Airworthiness Directives; Agusta S.p.A. Model A109E Helicopters

ACTION: Notice of proposed rulemaking (NPRM).

Airworthiness Directives; Robinson Helicopter Company Model R44 Helicopters

ACTION: Notice of proposed rulemaking (NPRM).

Figure 1

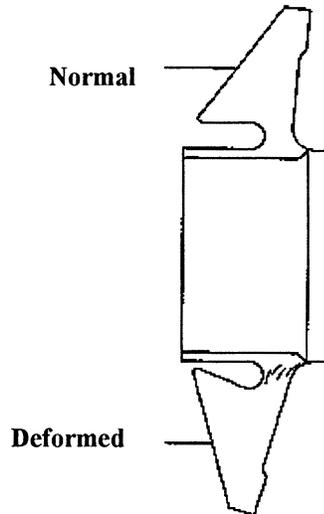
(b) Before each engine start, check the indicator for damage in accordance with Figure 1 of this AD. If damage is found, before further flight, replace the damaged indicator with an airworthy indicator, and replace the tail rotor yoke, P/N 406-012-102-107, with an airworthy tail rotor yoke.
